**Residential Housing & Apartment
Development on Zoned Lands at
Crodaun, Celbridge, Co Kildare
ABP- 307100-20**

**Traffic & Transport Submission to
An Bord Pleanála**

This report has been prepared as part of a submission to An Bord Pleanála with regard to Residential Housing & Apartment Development SHD application on Zoned Lands at Crodaun, Celbridge, Co Kildare by Crodaun Development Company Ltd., ABP Reference: ABP- 307100-20.

Figure 2.5 - Mode Share to Train Stations from the Crodaun Area

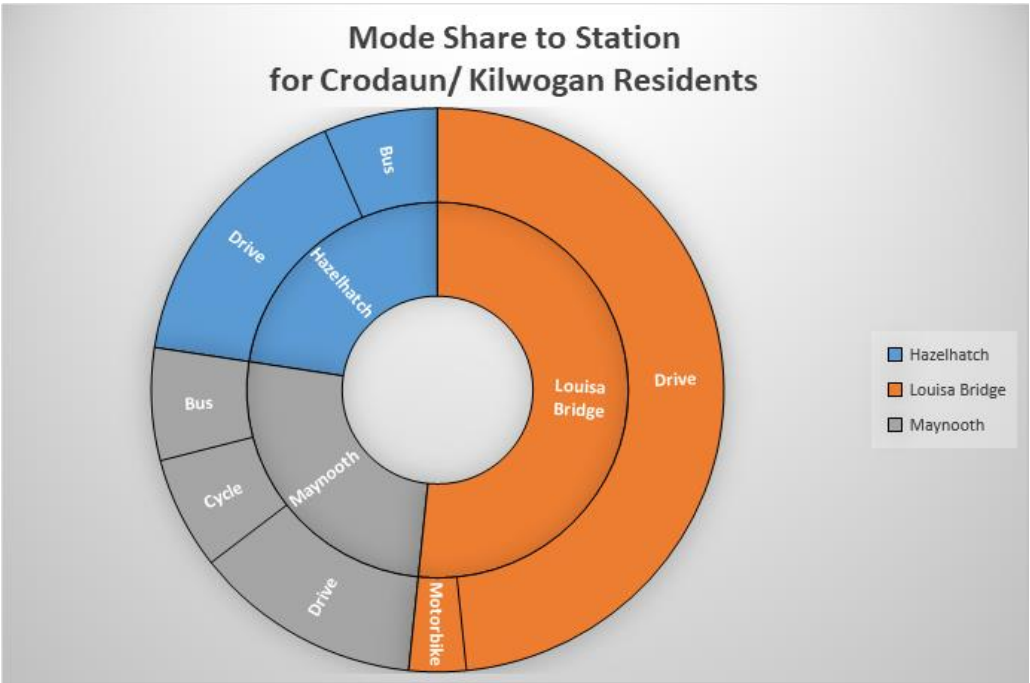
This highlights that over half of all journeys to a train station from Crodaun are to Leixlip Louisa Bridge and that the remainder are evenly split between Hazelhatch and Maynooth. Despite the applicant’s belief that the “dedicated pedestrian route and cycle track” from the site to Louisa Bridge Train station would be an attractive option for commuters, existing patterns of travel from the Crodaun area fail to support this - no residents from this area of town walk to the train station and the only station to which anyone cycles is Maynooth. The predominant mode of transport is by private car.

Figure 2.7 – Delay at Aghard’s Road Signalised Junction (AM)

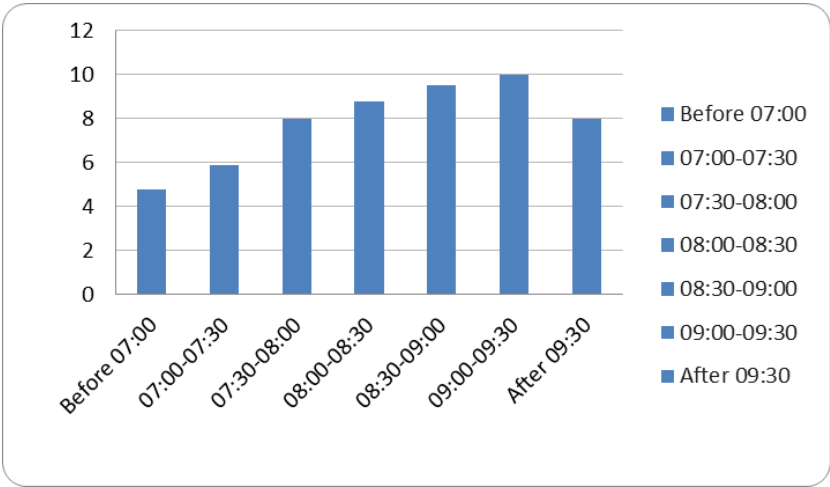
Appropriate scoping of the Traffic Impact Assessment would most likely have included additional junctions within the assessment, the Aghards Road signalised junction and Shackleton Road signalised junction are two keys junctions that should have been included. The Aghards Road signalised junction and Shackleton Road signalised junction are significant junctions in Celbridge Town and the lack of inclusion of these junctions fails to detail the development traffic impacts on these junctions.

The survey of residents provided information on driver delay in minutes experienced by drivers at Aghard’s Road and Shackleton Road signalised junctions. Figures 2.7 & 2.8 show the average delay experienced at these junctions in the mornings.

These delays confirm that these junctions are operating close to capacity at peak times which will be further exacerbated with the addition of development traffic.

Figure 2.8 – Delay at Shackleton Road Signalised Junction (AM)

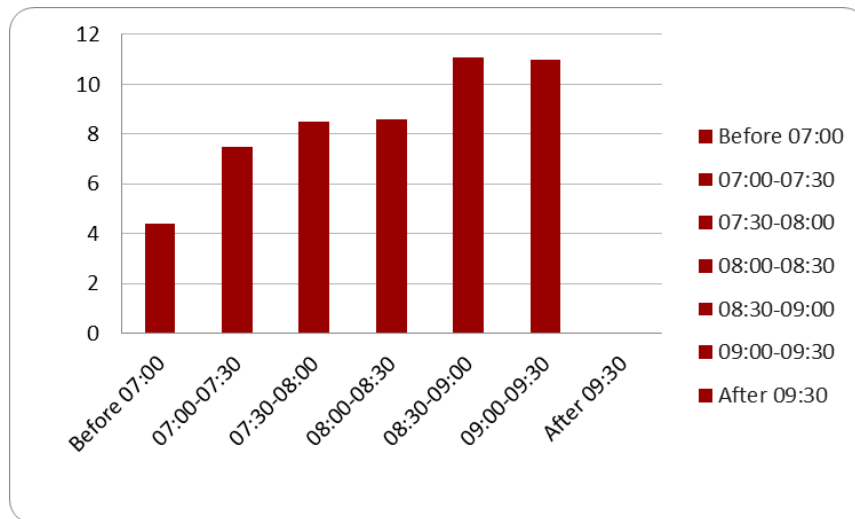
The Celbridge River Crossing Feasibility Report carried out in May 2015 included an assessment of the Shackleton Road signalised junction, this analysis showed two arms of this junction operating close to capacity in 2019. Additional development traffic would most likely push this junction over capacity.

Figure 2.10 - Crodaun Forest Phase 1 Delay at Junctions (AM)

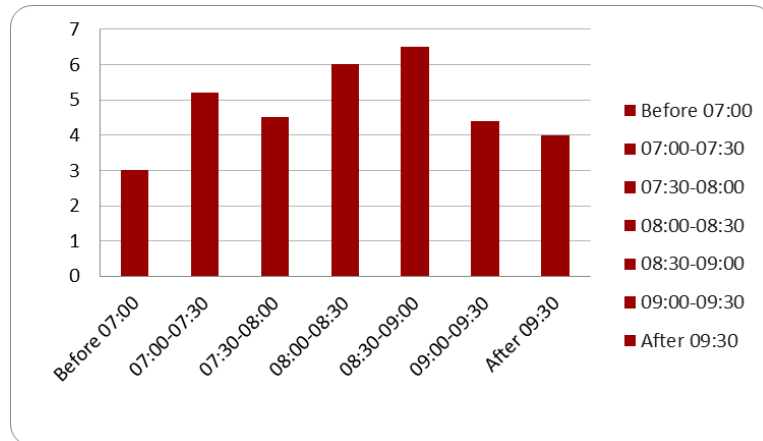
The NRB Transportation Assessment report failed to address the development traffic impacts of the Crodaun Forest Park Phase 2 access junction and only checked the impact on the Crodaun Forest Park Phase 1 & Kilwogan Lane junction. Crodaun Forest Phase 2 is the larger of the two development phases with 229 houses as compared to 69 houses in Phase 1.

It is clear from the figures above that residents in both the Crodaun Forest Phase 1 and Phase 2 developments are suffering significant delays when accessing the R405 Maynooth during peak times.

The NRB Transportation Assessment report fails to account for these existing delays in the traffic assessment of the Crodaun Forest Park (Phase 1) access junction, the analysis carried out with development traffic applied doesn't accurately model the impact on this junction and the increased delays due to the development traffic.

Figure 2.15 - Proposed Western Link Road Alignment

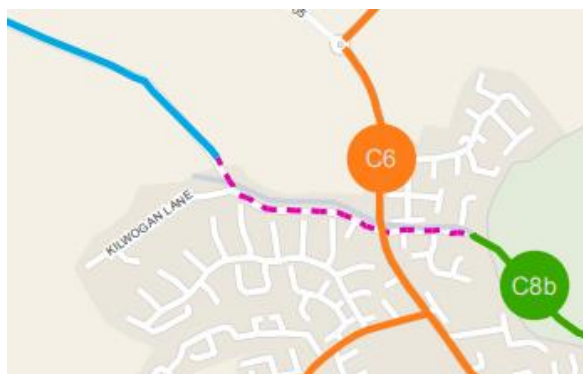
Sheet N16 of the Greater Dublin Area Cycle Network Plan details a feeder route along Kilwogan Lane, this route is also highlighted on the Map 8.1 of the LAP. These are detailed in Figure 2.15 below.

The An Bord Pleanála Inspector's report on the 302887-18 Strategic Housing Development consultation notes that Kildare County Council were seeking "Provision of pedestrian/cycle route along Kilwogan Lane or within subject site as per Celbridge LAP and indicated on map 8.1 of same".

The proposed development has not facilitated the provision of this cycle route within the site or along Kilwogan Lane.
